5TH AND VIRGINIA

Proposed MUP #3018037

# SECTION 02. RESPONSE TO EDG

- 1 Dog walk
- 2 Kitchen Area
- 3 Back-of-house Stairwell
- 4 Perforated Metal Panel
- 5 Vision glazed curtain wall
- 6 Overhead Weather Protection with Integrated Lighting

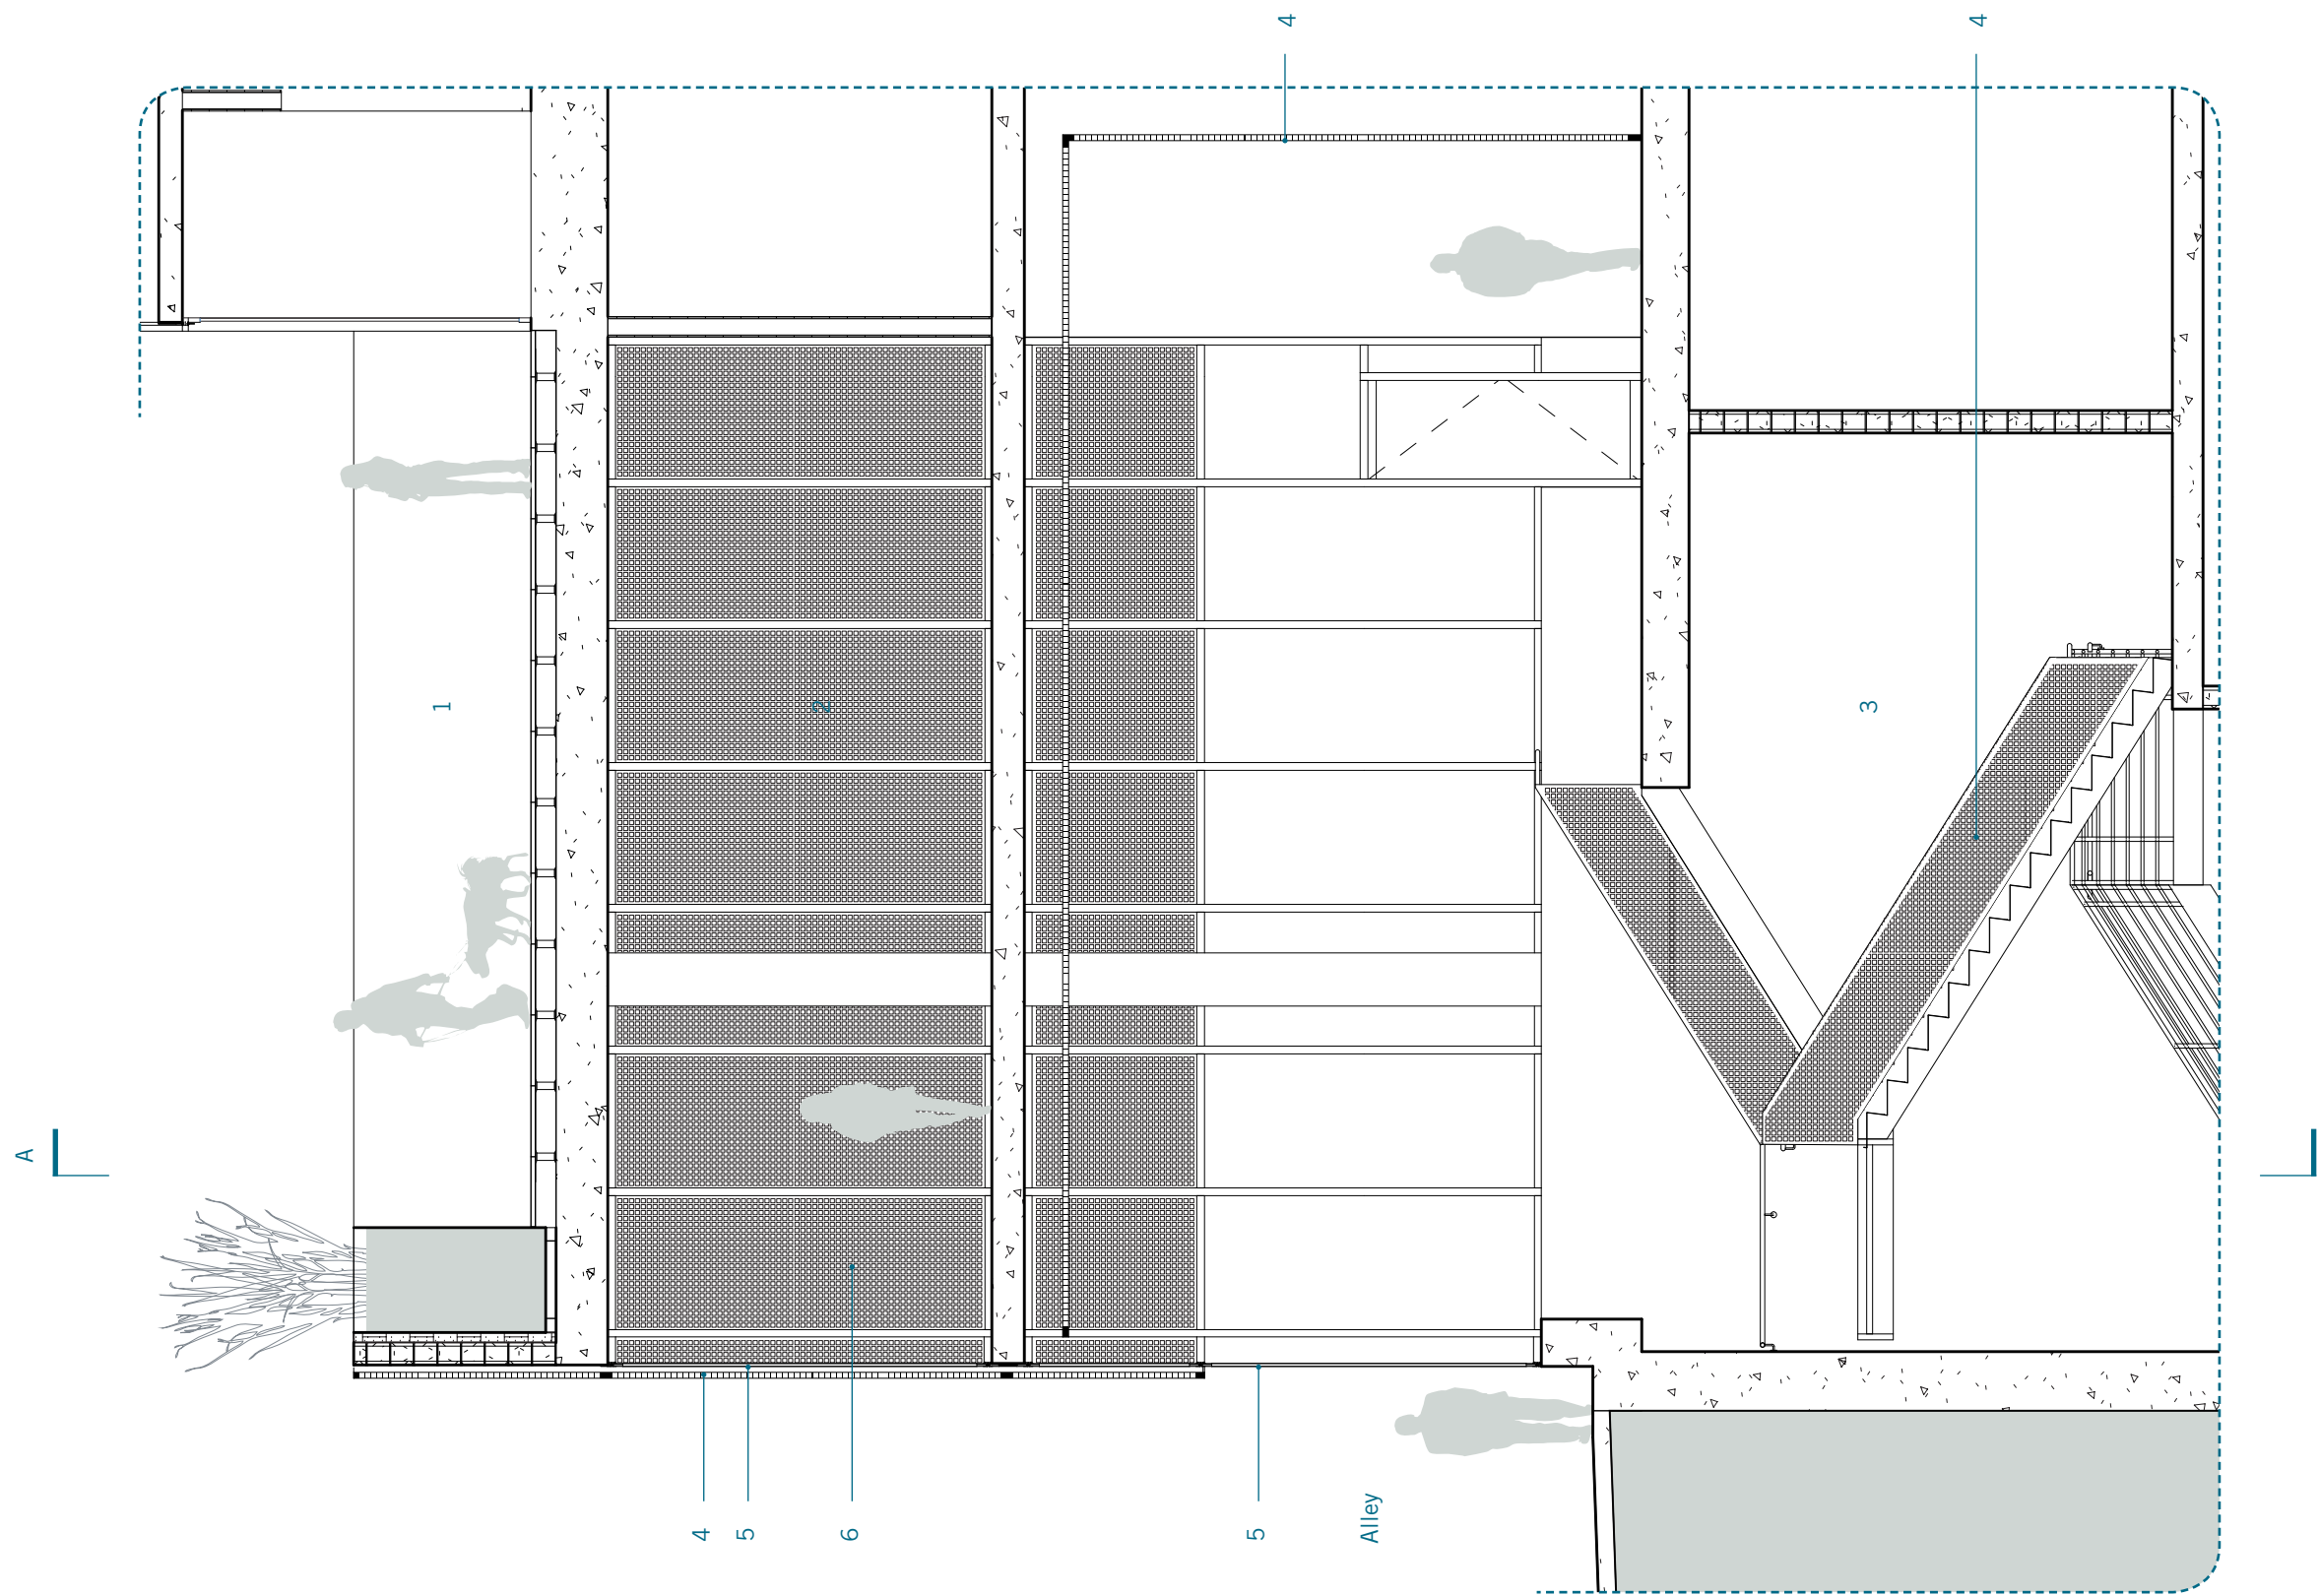
The Board agreed the west half of the Virginia frontage and the alley corner were far too blank as shown on pg 60, and regardless of proposed layering strategies, should show more transparency at the street and wrapping the corner, such as glass walls at the staff, security and corner stair shown on page 42. Shifted and perforated loading doors have potential, and more opaque layering techniques are acceptable on the southern part of the alley façade, beyond the part visible to Virginia. (C3, C6)

The northwest alley corner has been modified to maximize transparency into the security, staff, and south stair areas that front this portion of Virginia. Additional glazing has been introduced at the corner of the alley, which is visible from Virginia Street. The perforated panel 'layer' to the layered facade system has been raised to above the canopy line, and the perforated panels have been extended into the interior as a backlit layer to enhance the "inside/outside" reading of this space and create a highly transparent and interesting 'lantern' at the corner, while accommodating code required functions.
